Access Compliance Report

Public Rights-of-Way

(Island Curb Cuts)

Intersection ID: 7770	Main Street: E_ARROWHEAD_DR	Cross Street: N_TRYON_ST	Location:	S
ADA ID: 320B7040F369	Curb Cut Type: MedianRefuge2	Initial Pass/Fail: Pass	Overall Compliance: No	Severity Score: 15
Codes/Mitigation Info/Possible Solution		Field Measurements/Component Compliance

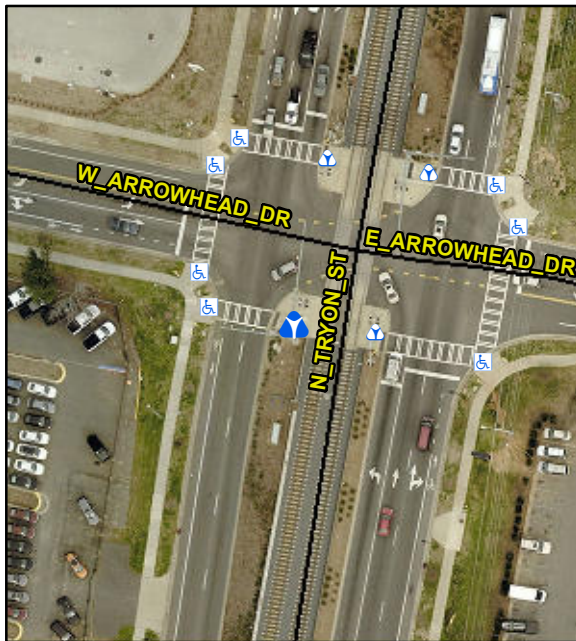
Remove & Replace Detectable Warning System. Grind Gutter Lip. Utility Present.

Compliance	Description	Data	Compliance	Description	Data
Yes	Refuge 1 Length (In)	96.0	Yes	Gutter 1 Ponding?	No
Yes	Refuge 1 Width (In)	120.0	No	Gutter 1 Lip Ht (In)	1.0
Yes	Refuge 1 Slope (%)	1.1	Yes	Gutter 1 Slope (%)	3.8
Yes	Refuge 1 X Slope (%)	0.6	Yes	Gutter 1 X Slope (%)	0.4
N/A	Painted X Walk1?	Yes	Yes	DWS 1 Provided?	Yes
N/A	X Walk 1 Direction	To W	Yes	DWS 1 Contrast?	Yes
N/A	X Walk 1 Width (In)	119.0	Yes	DWS 1 Length (In)	24.0
N/A	Road 1 Slope (%)	1.2	Yes	DWS 1 Full Width?	Yes
N/A	Road 1 X Slope (%)	2.3	No	DWS 1 Offset (In)	5.0
Yes	Refuge 2 Length (In)	109.0	Yes	Gutter 2 Ponding?	No
Yes	Refuge 2 Width (In)	120.0	Yes	Gutter 2 Lip Ht (In)	0.0
Yes	Refuge 2 Slope (%)	0.3	Yes	Gutter 2 Slope (%)	4.0
Yes	Refuge 2 X Slope (%)	0.2	Yes	Gutter 2 X Slope (%)	1.3
N/A	Painted X Walk2?	No	Yes	DWS 2 Provided?	Yes
N/A	X Walk 2 Direction	To E	Yes	DWS 2 Contrast?	Yes
N/A	X Walk 2 Width (In)	N/A	Yes	DWS 2 Length (In)	24.0
